ENVIRONMENTAL APPEALS BOARD
 UIC Class VI Permit IL-155-6A-0001

Marquis Biocarbon Project

Petition to Appeal the Final Permit

Summary of Eleven Issues Presented for Review

Operational and 10,000-year plume track of the pickle-liquor plume in the Mt. Simon Sandstone. Source: U.S. EPA proposal to reissue exemption to ArcelorMittal-Hennepin Works.

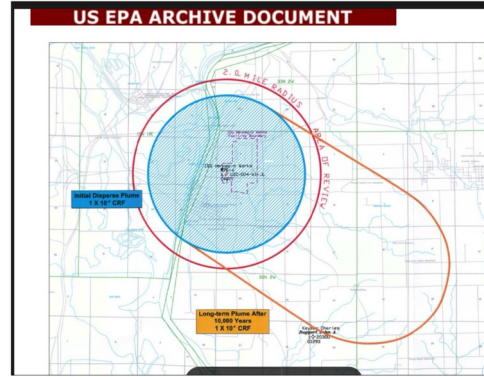
The computational model omitted the WPL-1 hazardous-waste plume

Marquis modeled how its CO₂ and pressure will move underground — but ignored 276 million gallons of acidic, metal-laden steelmaking waste (chromium, iron, chlorides) that ArcelorMittal injected into the same Mt. Simon formation from the late 1960s through 2009, just 1.25 miles from the planned CO₂ well. The waste's permitted chromium concentration is roughly 12,000 times the Safe Drinking Water Act limit.

The Illinois EPA — the agency that permitted and closed the hazardous-waste well — objected that Marquis's CO₂ injection would re-pressurize the formation and could mobilize that waste beyond its predicted limits, toward drinking water.

Before issuing a Class VI permit, Region 5 must find under 40 C.F.R. § 144.12 that injection won't endanger drinking water. It didn't. The EPA assumed pressure had returned to baseline and deferred verification to a Marquis measurement during pre-operational testing after issuing the permit.

Carbon dioxide migration along faults at the Illinois Basin–Decatur Project, revealed by time-shift analysis of seismic monitoring data. Bukar et al. (2025).

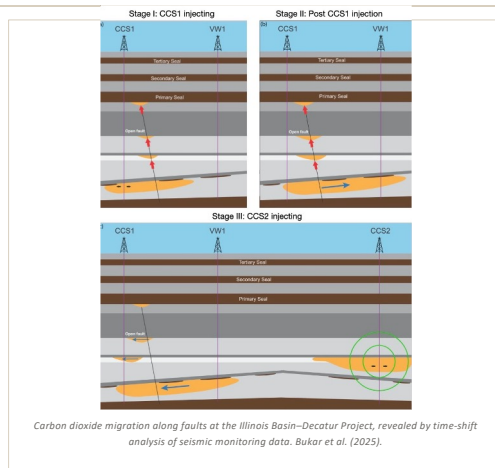
Reliance on Marquis's modeling conflicts with peer-reviewed IBDP evidence

At the Illinois Basin–Decatur Project — same Mt. Simon Sandstone formation — seismic monitoring (Bukar et al. 2025) showed CO₂ migrating upward along undetected faults to the Eau Claire Shale caprock, contrary to the pre-injection prediction (at “90% confidence”) that the plume would stay deep within the formation.

Marquis's own application admits the injection site comprises seven distinct depositional environments — braided fluvial channels, tidal systems, eolian dunes — settings where fluid flow is notoriously hard to predict.

Marquis relied on the same class of deterministic model that failed at IBDP, and EPA's own 2013 Class VI guidance recommends geostatistical/stochastic methods for exactly these heterogeneous conditions. Region 5 ignored both — rendering its reliance on Marquis's model clearly erroneous under §§ 146.84(c)(1)(ii) and 124.17(a)(2).

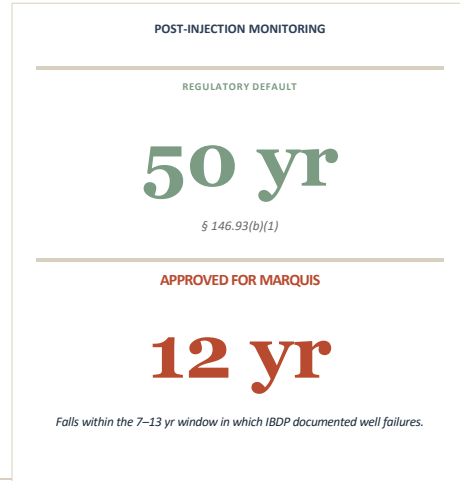
The 12-year alternative post-injection site care period lacks substantial evidence

Region 5 cut post-injection monitoring from the 50-year default under § 146.93(b)(1) to 12 years — a fourfold reduction — without the “substantial evidence” § 146.93(c) requires.

The approved 12-year window also falls within the 7–13-year range in which IBDP — using state-of-the-art well construction — documented well failures. Region 5 did not address this evidence.

WELL LIFE vs. PROJECT LIFE

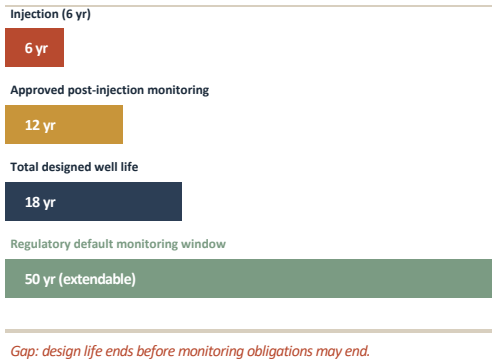
Injection wells are designed for only 18 years — not the project life

40 C.F.R. § 146.86(b)(1) requires casing and cement to be designed for the life of the geologic sequestration project. That life is not capped at 18 years (6 years of injection plus 12 years of monitoring).

But the Marquis wells are engineered for just 18 years — the injection phase plus the truncated PISC window. That fails both rules at once: the wells aren't designed for the project's full life, and the Director's extension authority is illusory because extending monitoring requires functioning wells — and by then there won't be any.

Wells designed for only 18 years total (6 yr injection + 12 yr monitoring) cannot reliably function during any continuation or extension.

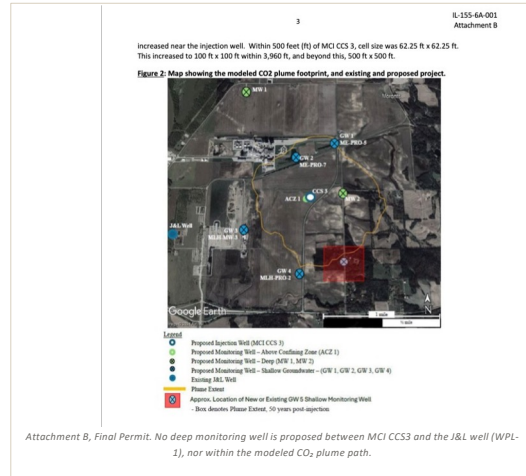
Monitoring-well network does not provide direct injection-zone coverage

Marquis's two deep monitoring wells sit outside the modeled CO₂ plume path, and no monitoring well is placed between Marquis's injection well and the existing hazardous-waste well. Because the modeled CO₂ plume appears to intersect the two-mile-radius hazardous-waste plume, an undetected interaction could harm drinking water before it's discovered — failing the § 146.90(d) obligation to track the CO₂ plume.

The public never had the chance to object to this placement. Between the draft and final permit, EPA reassigned the deep injection-zone monitoring role to MCI MW-2 — but the draft permit had identified a different well in that role, so commenters could not evaluate whether MW-2 was actually sited where the regulation requires. Region 5 issued no re-notice under §§ 124.10(d) and 124.13.

"Seismically stable" finding by Region 5 despite historical earthquakes on the Peru Monocline — including two within the AoR — that could affect containment if induced seismicity occurs.

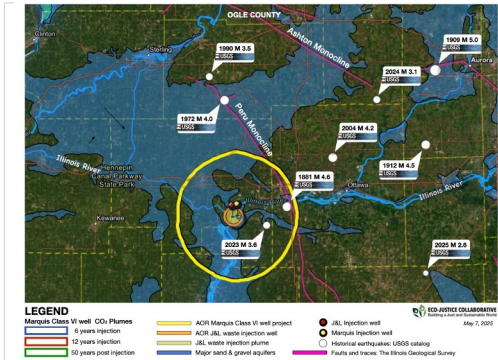
Region 5 called the AoR "seismically stable" despite at least three Peru Monocline earthquakes — two M4.6 and M5.1, large enough to damage buildings. It required no fault-stability analysis under § 146.82(a)(3)(v) or § 146.83 — contrary to EPA's own Class VI guidance — and never modeled whether injection could trigger quakes.

Two quakes hit inside the AoR — the 1881 M4.6 near LaSalle (which Region 5's Response to Comments misdates as 1972) and the November 2023 M3.6 near Standard, IL. Larson (2002) and Carpenter (2011) both concluded the Monocline may have been reactivated — findings Region 5 did not address.

§ 146.84(c) requires analyzing seismic risks in both directions — how Marquis injection could affect nearby wells, and how those wells could affect the project. Region 5 did neither for the co-located J&L hazardous-waste well, leaving uncharacterized the risk of induced quakes damaging J&L containment or opening cross-contamination pathways.

Figure 2, Attachment H of Final Permit. Only 63 ft of separation — with no confining unit — between the perforation at 4,791 ft and the pre-Cambrian basement.

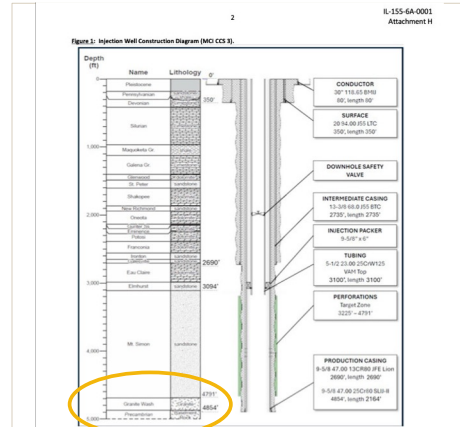
Only 63 feet of permeable “hot sand” separates CCS3’s deepest injection point from the Precambrian basement — the deep bedrock where most Illinois earthquakes originate. That’s roughly one-quarter of the buffer ADM built into CCS #2 in Decatur, a precaution taken after its CCS #1 pilot produced substantial microseismicity.

ADM CCS#1 — perforated only ~8 ft above basement — produced 2011–2014 basement microseismicity. ADM responded by perforating CCS#2 shallower, with a dedicated Argenta buffer. Marquis has not followed that lesson.

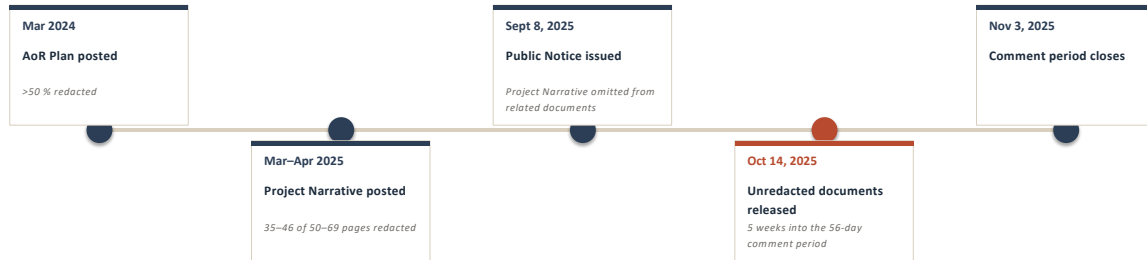
Application materials were substantially redacted during most of the comment period

More than 50% of the AoR & Corrective Action Plan and Project Narrative were redacted during most of the 56-day comment period. EPA's Sept. 8, 2025 Public Notice omitted the Project Narrative from “Related Documents” entirely and posted only an 11-page abbreviated version of the 183-page AoR Plan. Unredacted versions were released only on October 14, 2025 — five weeks into the comment period, one day before EPA's availability session, and 15 days before the hearing.

These materials contain the geologic, modeling, and site-characterization data on which Region 5's § 144.12 non-endangerment finding rests. Region 5's framing — that unredacted release is a discretionary “courtesy,” not a requirement — is inconsistent with 40 C.F.R. §§ 124.10(d)(1)(vi) and 124.18 and warrants Board guidance on CBI handling in Class VI permitting.
